SULPHUR SPRINGS  
MASTER DEVELOPMENT PLAN

MASTER  
DEVELOPMENT PLAN

SULPHUR SPRINGS  
SUBDIVISION

The City Staff Development Review Committee has reviewed Sulphur Springs Master Development Plan **M.D.P. # 875**. Please find enclosed a signed copy for your files. Your plan was accepted however please note the following:

TYPICAL STREET SECTION  
N.T.S.

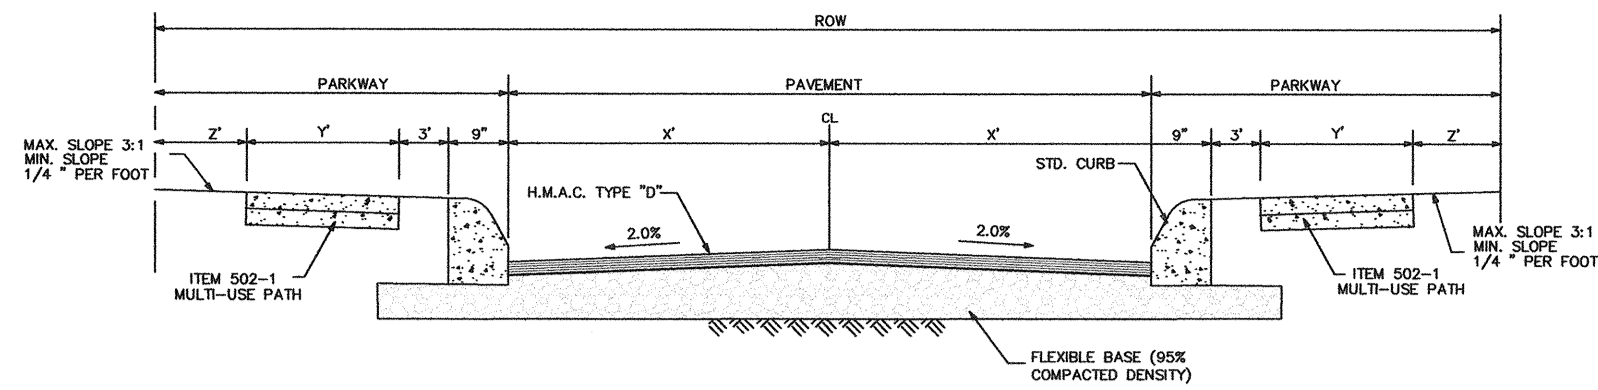
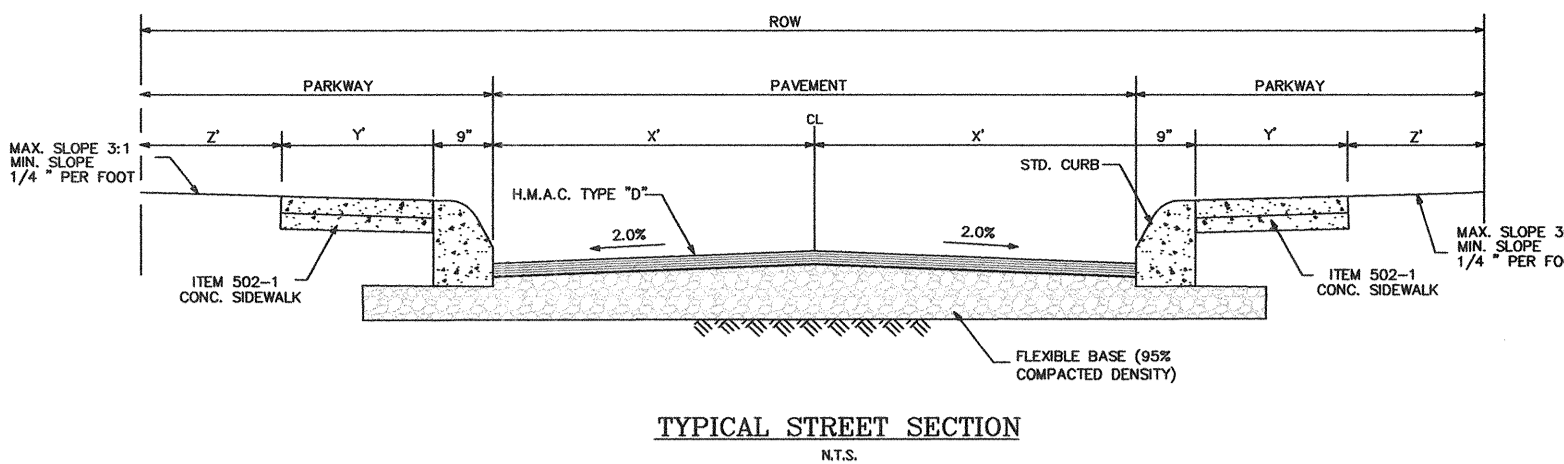
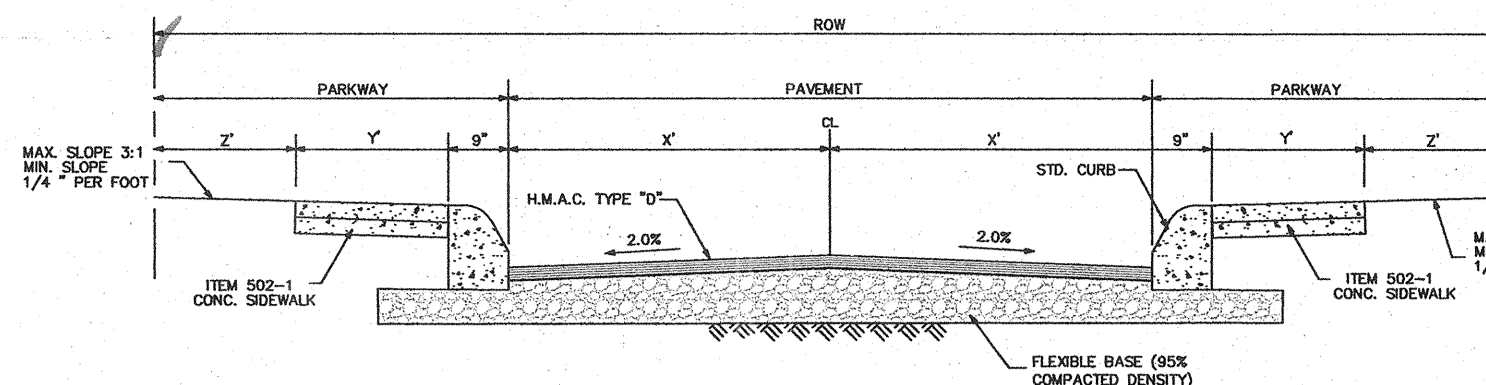
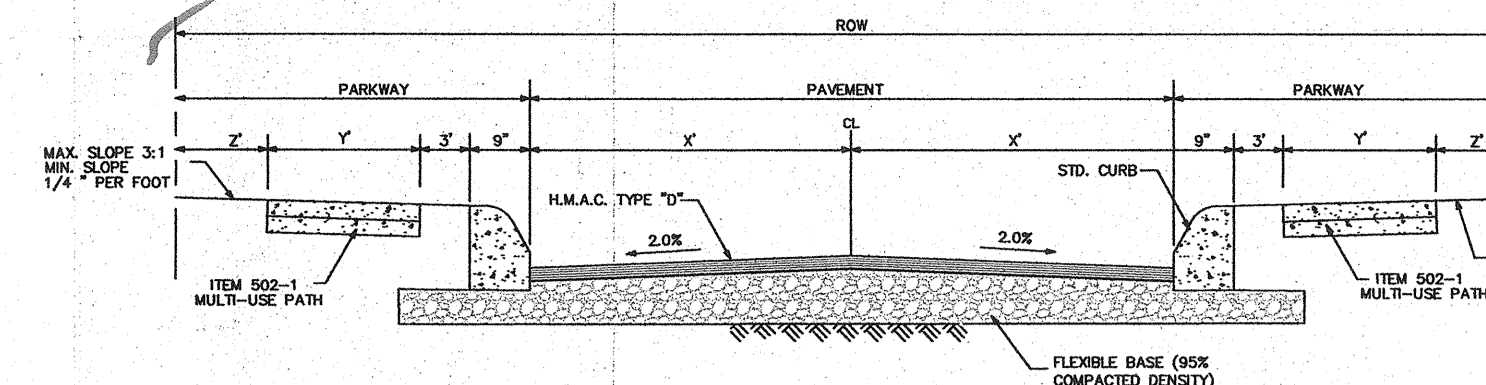
- Please refer to item 502-1 as a "multi-use path" not a "conc. sidewalk"
- please add a note similar to the following "Bicycle Facilities shall be provided in accordance with City of San Antonio UDC requirements (per Ordinance #100741)".
- Is the other 70' typical street section even necessary to be shown in the table? It seems confusing to me, but if you make the above 2 changes I'm ok with leaving it as is.

- Request additional street section detail.
- As required in the Bicycle Master Plan (Ordinance 100741 - approval by City Council April 21, 2005), identified future collector and arterial roadways will be required to include bicycle facilities (path or lane).
- Bicycle facilities for collector roadways may consist of one of the following: a marked on-street bicycle lane, along side each driving lane, a two-way, marked, off-street, multi-use path on one side of the road; or one-way marked off-street, multi-use path on both sides of the roadway.
- All facilities must comply with AASHTO guidelines for bicycle facilities.
- Any additional square footage for path construction may be counted toward required park credits.

We'll revise the text and add the note. However, we are proposing two different pavement section in the 70' row. One south of the drainage easement without the bike lane and one north of the drainage easement with the bike lane. If you have any question, please call me at 494-0088. Thank you for your assistance.
